2400 Bryan Street

2400 Bryan Street Urban Design Peer Review 01.19.2018

BRYAN ST. MIXED-USE PRELIMINARY STUDY

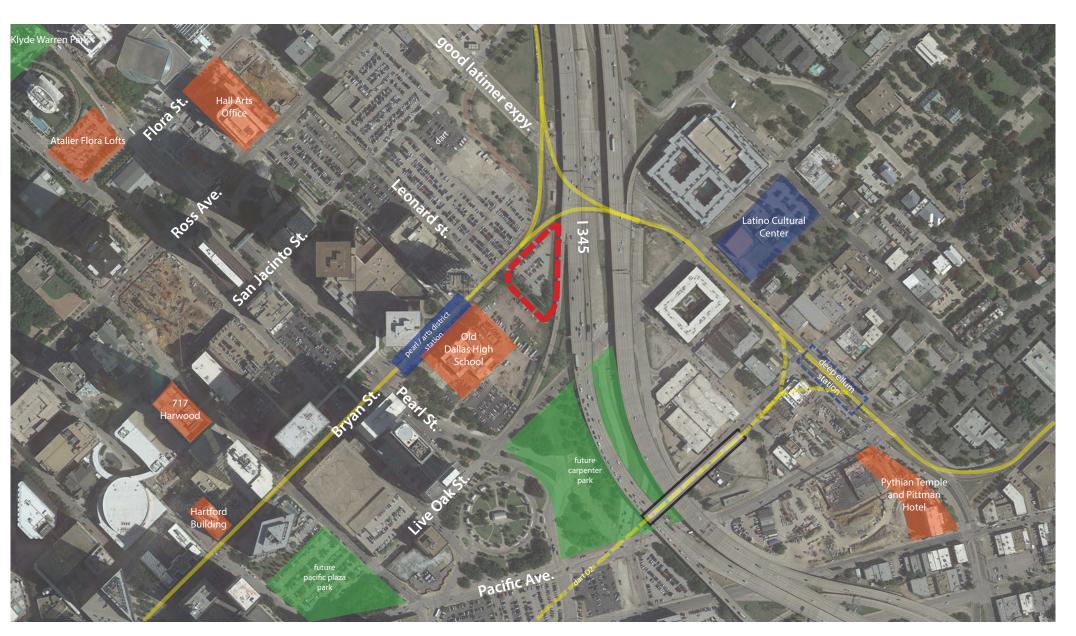
[3] Exposed structured parking should be concealed within building envelope or visually integrated into the overall building facade design, where visible from the public realm -

Exposed garage faces should be avoided where visible from the public realm. This is particularly important at the pedestrian level where ground floor uses are encouraged.
